Work Order ID 137025

Item Name: Crosstube Turning Detail

DART AEROSPACE LTD		Work Order:	137025
Description: Crosstube Assembly		Part Number:	D206-667-243
Inspection Dwg: D206-667-243 Rev: C		Page 1 of 2

DRAWING NO. D206-667-243	TITLE CROSSTUBE ASS'Y (206L HIGH AFT)	REV. C	DART AEROSPACE LTD ENGINEERING ORDER		D.E.O. NO. D206-667-243-C-1	SHEET NO. SHEET 1 OF 1	SCALE NTS
DRAWN <i>q</i>	CHECKED <i>ASS</i>	MFG. APPR. <i>RB</i>	APPROVED <i>MP</i>		DE APPR. <i>#</i>		
DATE 11.07.15	DATE 11.07.20	DATE 11.07.21	DATE 11/07/21		DATE 11.07.21

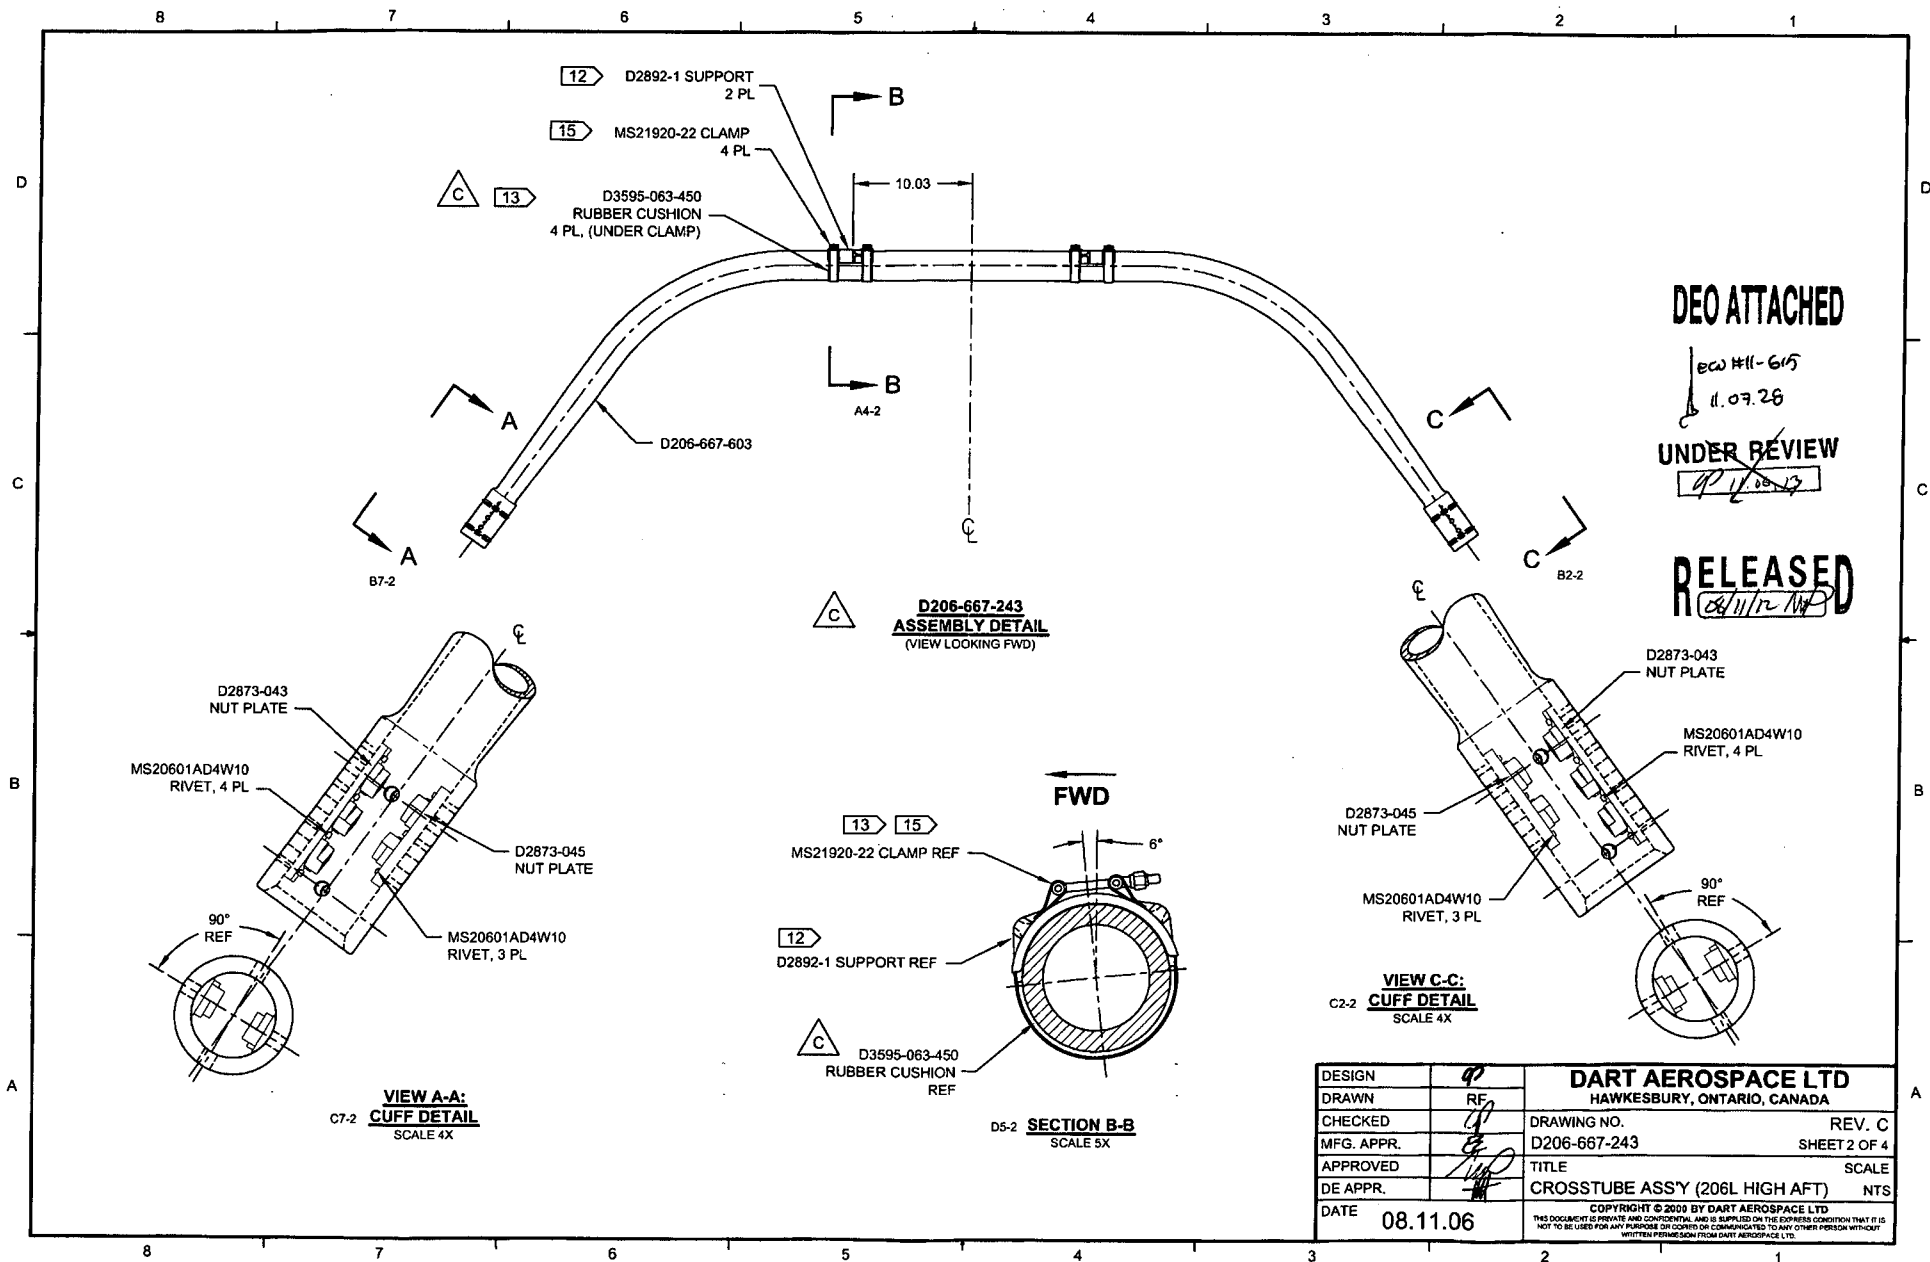
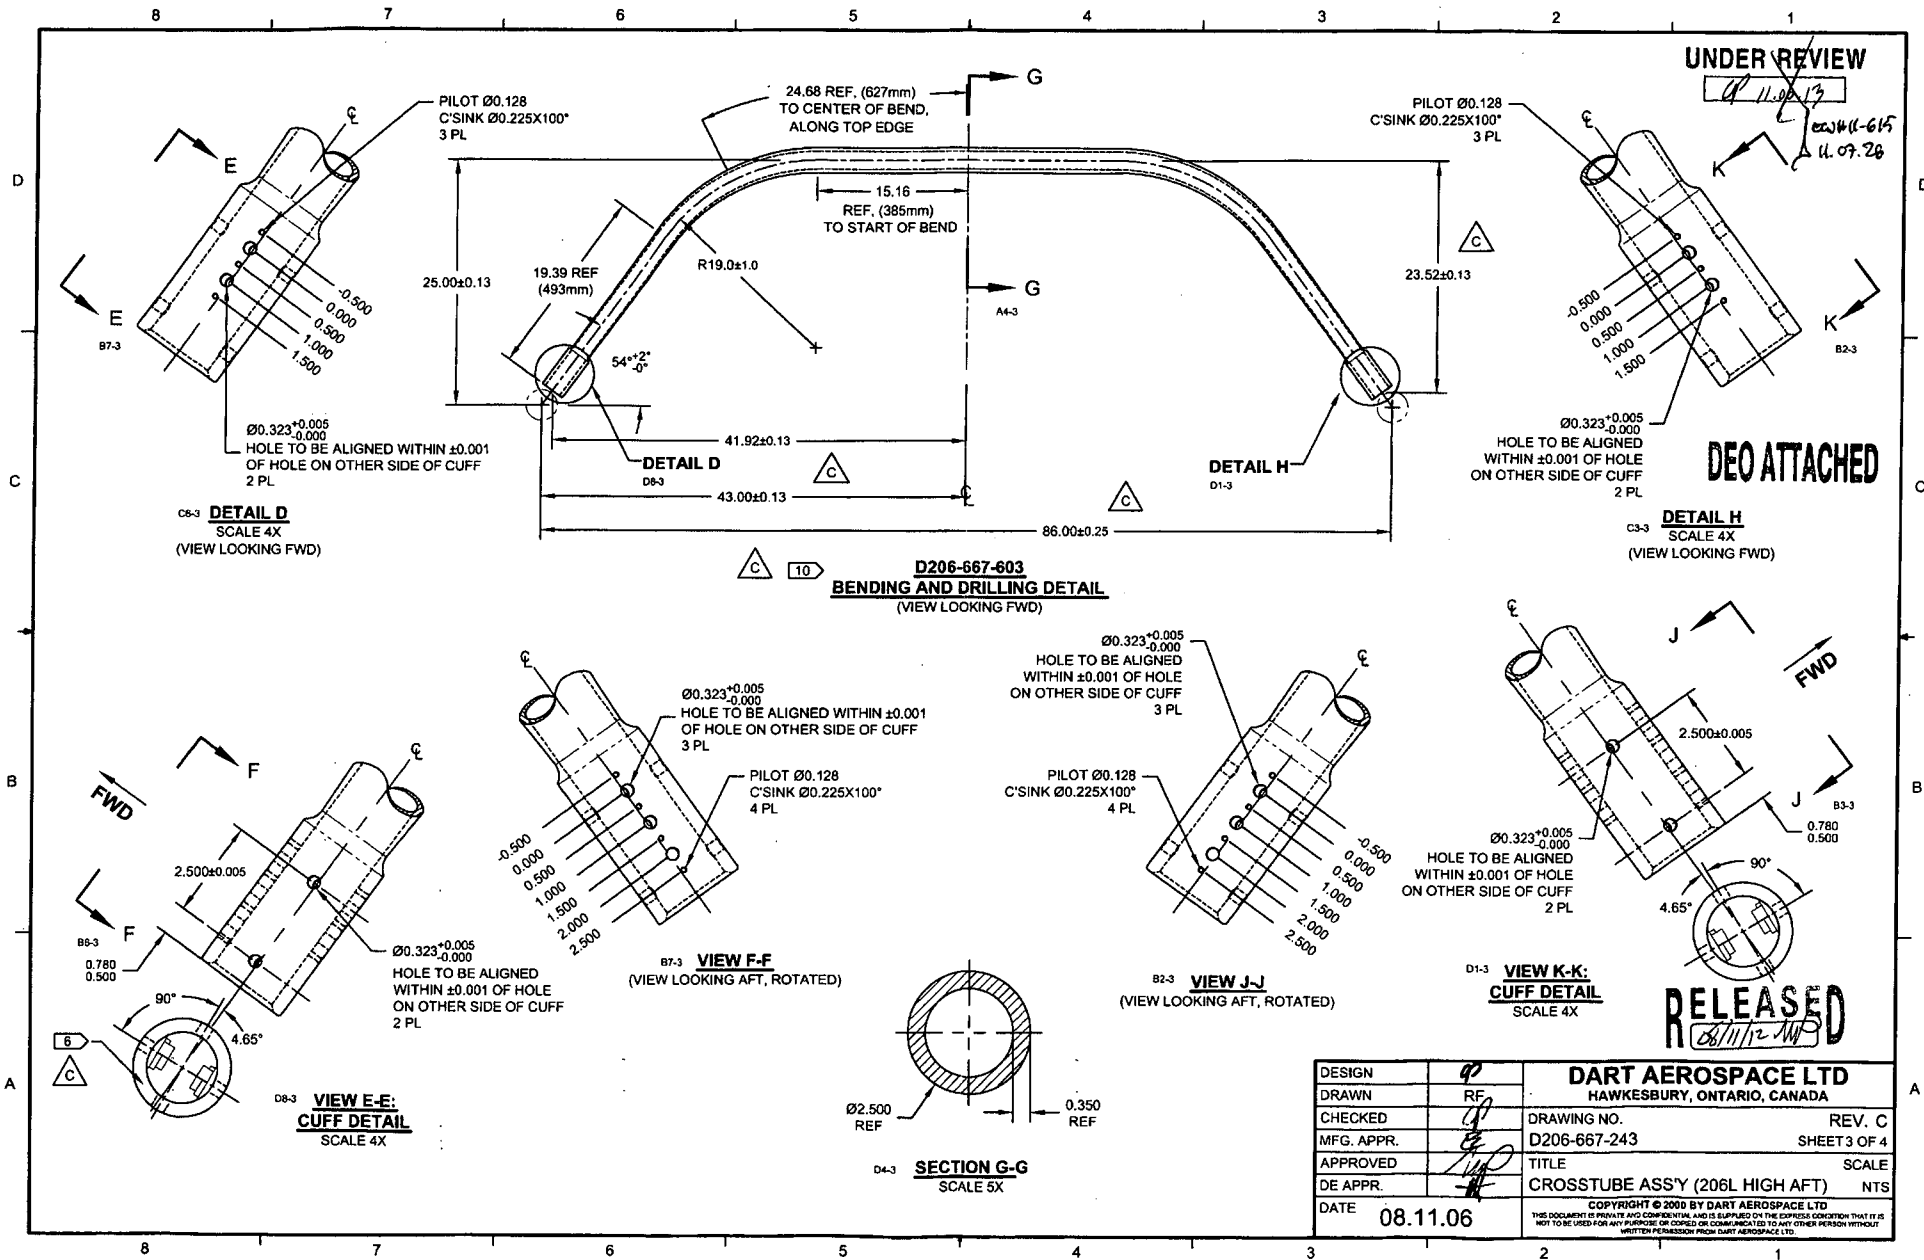
PURPOSE:

REPLACE MAGNOBOND WITH PROSEAL.

NOTE 12 & 15, SHEET 1 IS AMENDED AS FOLLOWS:

IS:

Item	Qty -243	Part Number	Description
9	A/R	PROSEAL 890 B-2	SEALANT, AMS-S-8802 CLASS B-2

WAS:

9	A/R	MAGNOBOND 6398	ROCKWELL SPECIFICATION RBO-120-023 ADHESIVE (TEXTRON/BELL SPEC. 299-947-100, TYPE II, CLASS 2 ADHESIVE)
---	-----	----------------	---

IS:

- 12) TO INSTALL D2892-1 SUPPORT: ABRABE MATING SURFACE OF SUPPORT AND CROSSTUBE WITH 180-GRIT SANDPAPER AND REMOVE RESIDUE WITH MEK (OR EQUIVALENT). APPLY A 0.04" TO 0.07" THICK LAYER OF PROSEAL 890 CLASS B-2 (OR AMS-S-8802 CLASS B-2) SEALANT TO MATING SURFACE OF SUPPORT.
- 15) TORQUE CLAMPS 80 TO 100 IN-LB. ENSURE AT LEAST 1.5 THREADS SHOWING IN SAFETY AND THAT NUT HAS NOT BOTTOMED-OUT AFTER TORQUING. **PRIOR TO PACKAGING, RE-CHECK TORQUE ON CLAMPS AFTER PROSEAL 890 SEALANT HAS CURED FOR 72 HOURS.**

WAS:

- 12) INSTALL D2892-1 SUPPORT USING 0.03" TO 0.06" THICK LAYER OF MAGNOBOND 6398 PER QSI 015. LET CURE FOR 12 HOURS AFTER INSTALLATION AND PRIOR TO PACKAGING.
- 15) TORQUE CLAMPS 80 TO 100 IN-LB. ENSURE AT LEAST 1.5 THREADS SHOWING IN SAFETY AND THAT NUT HAS NOT BOTTOMED-OUT AFTER TORQUING.
